**MINUTES  
OF  
IOWA DOT SPECIFICATION COMMITTEE MEETING**

**July 12, 2018**

**SPECIFICATION REVISION SUBMITTAL FORM**

<b>DETAIL SHEET</b>	<b>500-20</b>
REVISION: 10/15/13 1. Add 1/2" depth to concrete base to allow for embedment.	DATE: 10/15/13 4

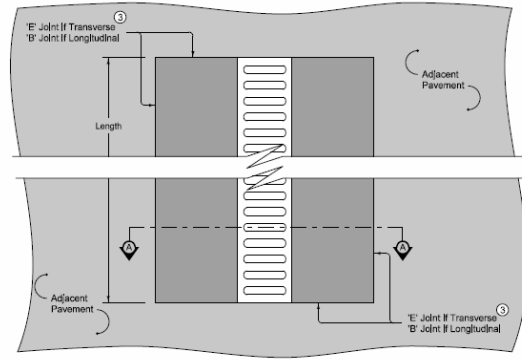
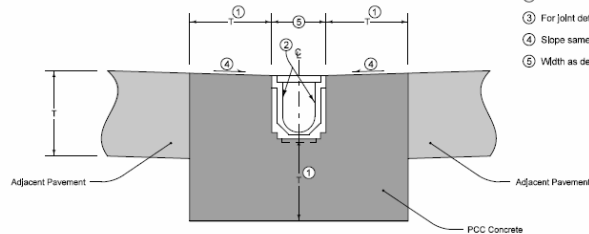
**Reason for Revision:** Detail 500-20 for Continuous Trench Drain has remained unchanged since 2013. The office of Design would like to convert this to a Standard Road Plan and move the notes into the Standard Specifications. Approved manufacturers will go into MAPLE.

**Comments:** Following the meeting, the Specifications Section and Office of Design decided to rename continuous trench drains to linear trench drains to more accurately reflect the item.

Also after the meeting, the Specifications Section and Office of Design decided to insert the linear trench drain specifications into the existing Section 2435, Sanitary and Storm Sewer Structures.

Bid item 2502-2308110, Continuous Trench Drain (500-20) will change to 2535-0252100, Linear Trench Drain (SW-521).
